EXHIBIT A
PERMIT DOCUMENTS

AIR PERMIT ROUTING/APPROVAL SLIP-Permits

AI No.	232172	Company	Venture Global CP2 LNG LLC	Date Received	
Activity No.	PER20220001	Facility	CP2 LNG Terminal	Permit Type	Public TV
CDS No.		Permit No.	0560-00998-V0	Expedited	<input checked="" type="checkbox"/> yes <input type="checkbox"/> no

PUBLIC COMMENTS RESPONSE SUMMARY

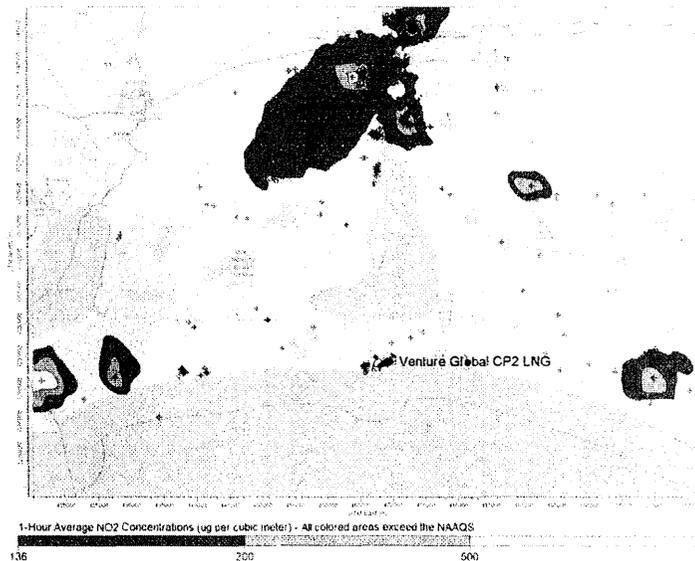
Comment No. 6

As explained in the attached Wingra Report, the CP2 analysis contains a number of shortcomings, including:

- CP2 failed to identify all of the possible exceedances of the NAAQS that could occur throughout the entire 50 km modeling domain surrounding their facility. CP2 only included receptor locations where project emissions exceeded the SIL. This approach omitted most of the area within the possible 50 km modeling domain for which AERMOD provides accurate modeling results. The off-property sources included in the CP2 analysis were located throughout this 50 km modeling domain.
- CP2 failed to include 26 intermittent sources in its NO₂ modeling analysis. These include the emergency generators and fire water pumps. CP2 included these intermittent sources in the modeling analysis for PM_{2.5} but not the analysis for NO₂. These sources have very high short-term NO_x emission rates.
